ADDENDUM

AD #4

Project **West Point Dairy - Hyrum - Storage Warehouse**
Project No. **250429500**
Location **Hyrum, Utah**
Date **August 21, 2026**

STORAGE WAREHOUSE EXPANSION FOR:
WEST POINT DAIRY PRODUCTS

ELECTRICAL FIRST FLOOR PLAN - AREA 'A' - LIGHTING

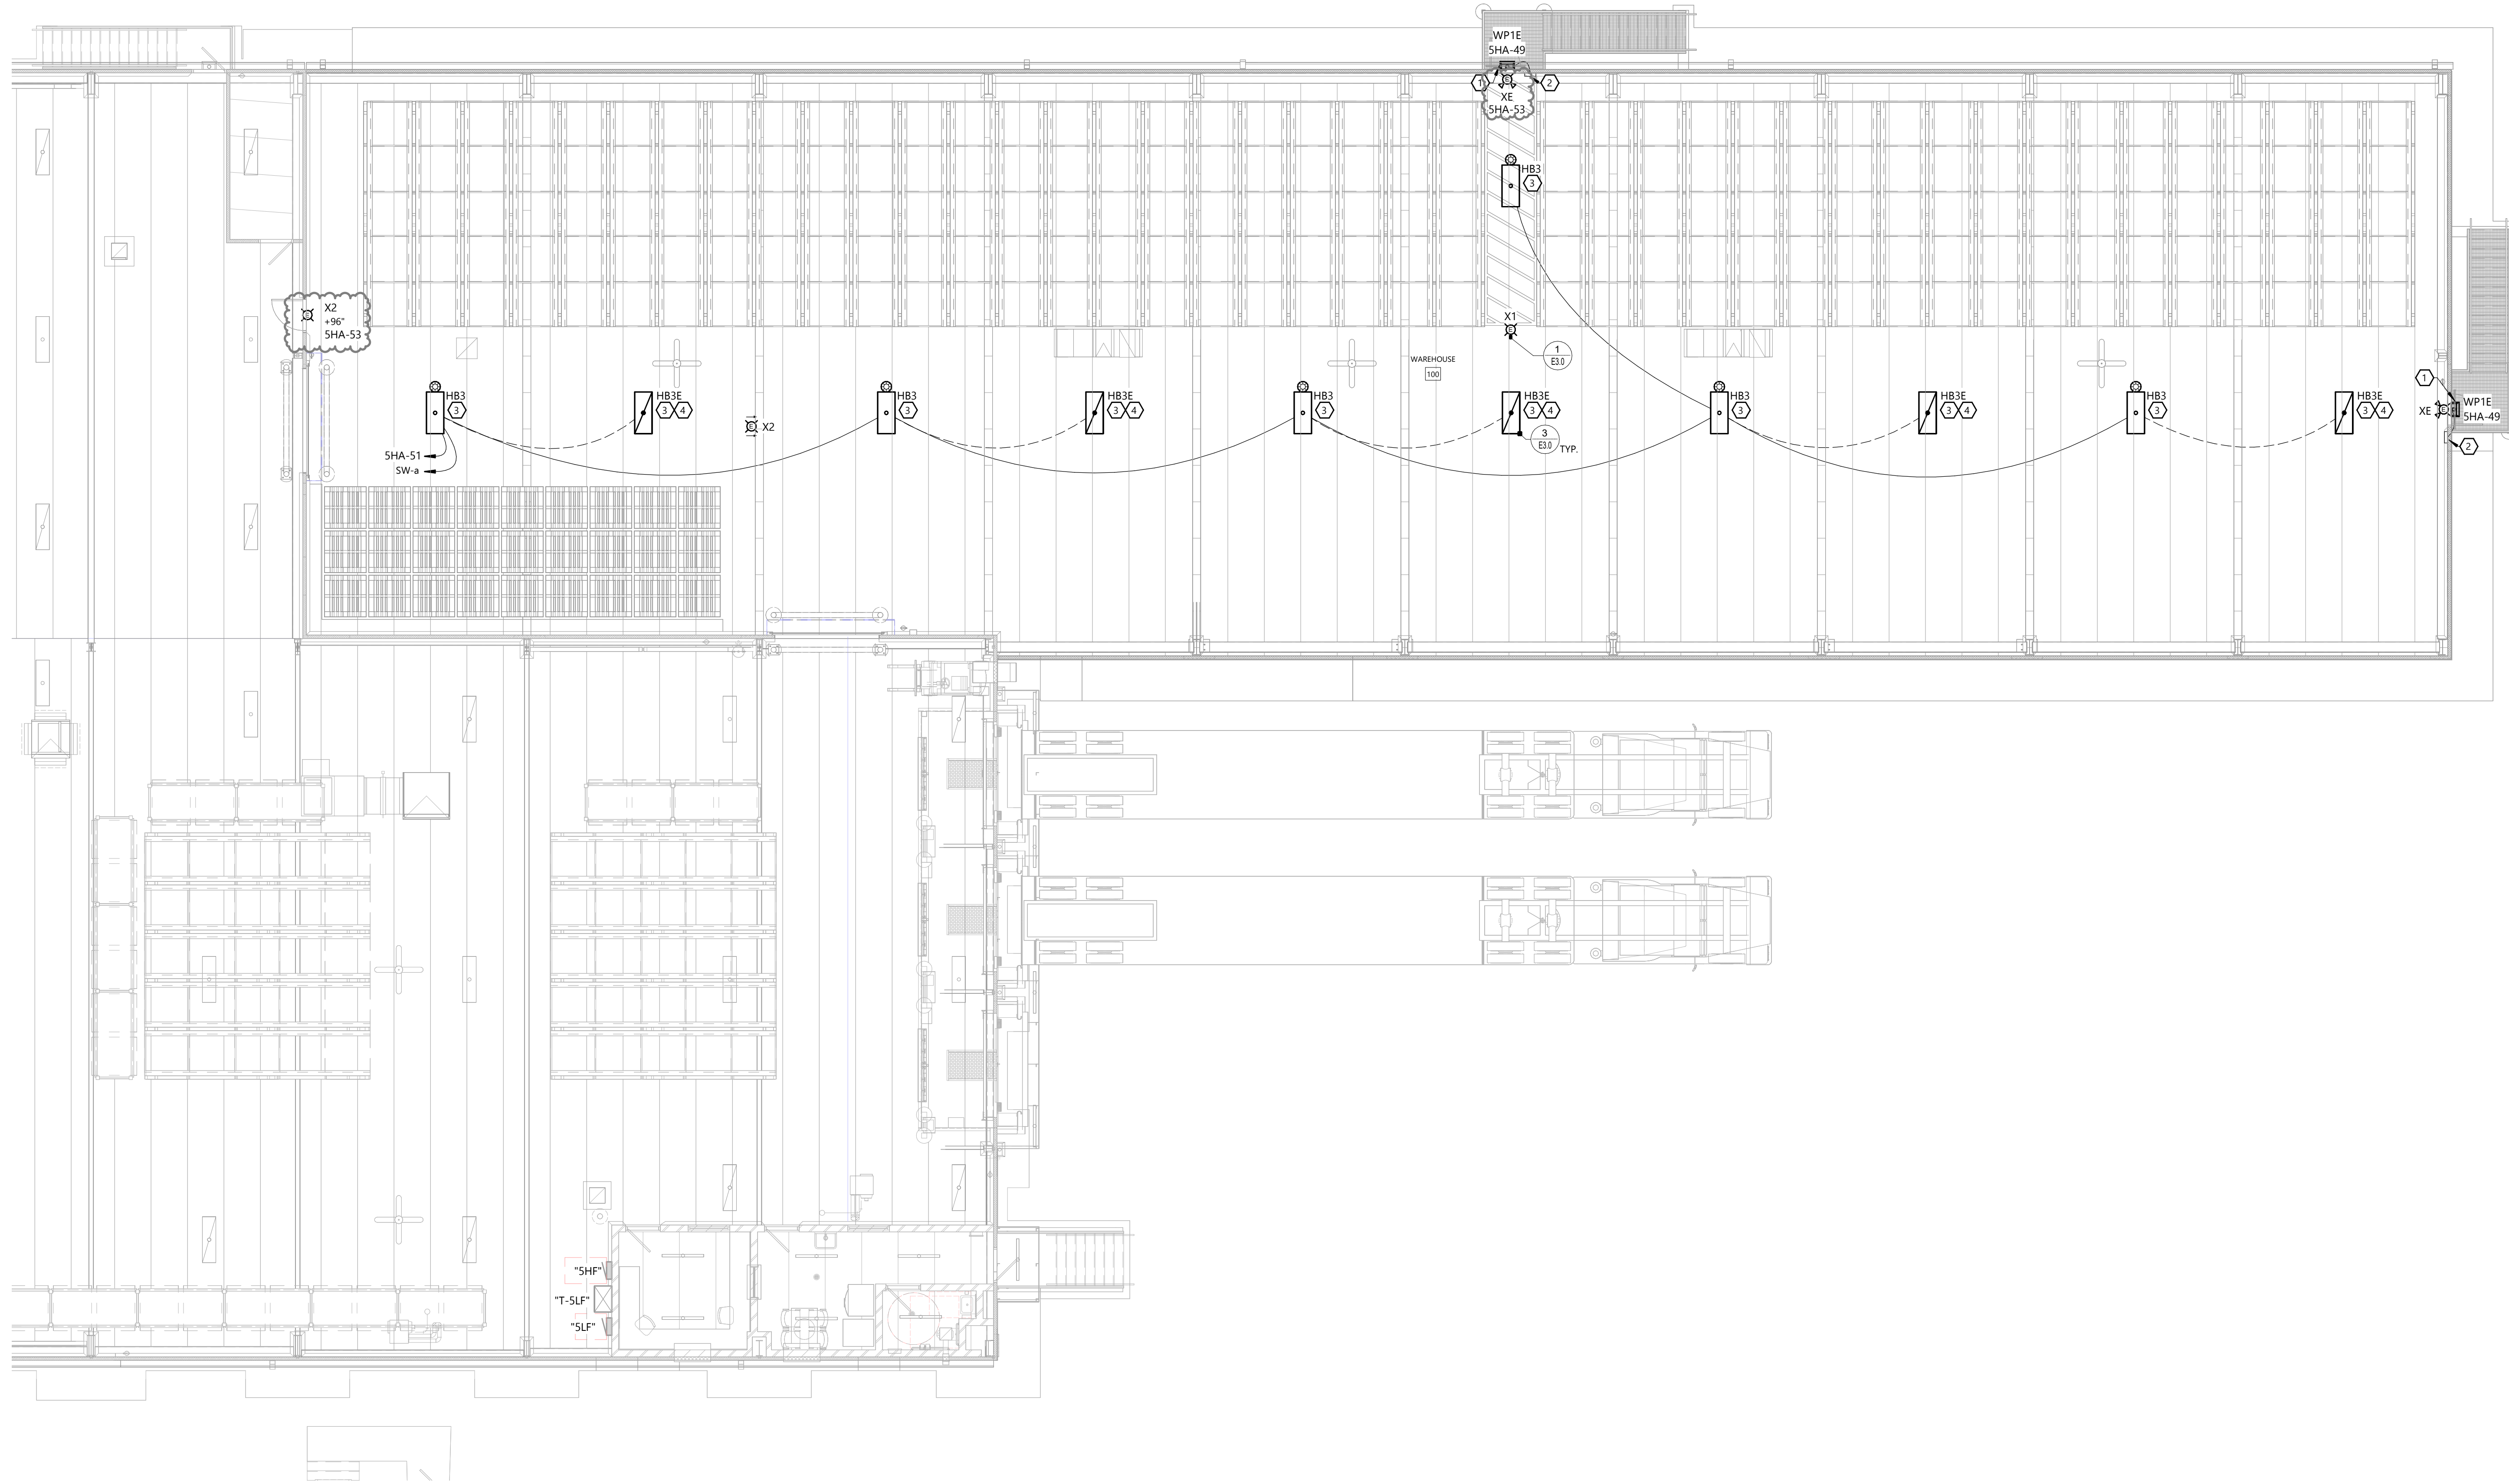
T1.0	Updated sheet index.
T1.1	Updated future project footprints.
	Updated Square footages.
T1.1PH	Updated Sheet.
A1.0	Updated future project footprints
S2.4	Updated top plate of silo embed ring to stainless steel
E1.1AL	Added circuit tags to emergency exit signs.
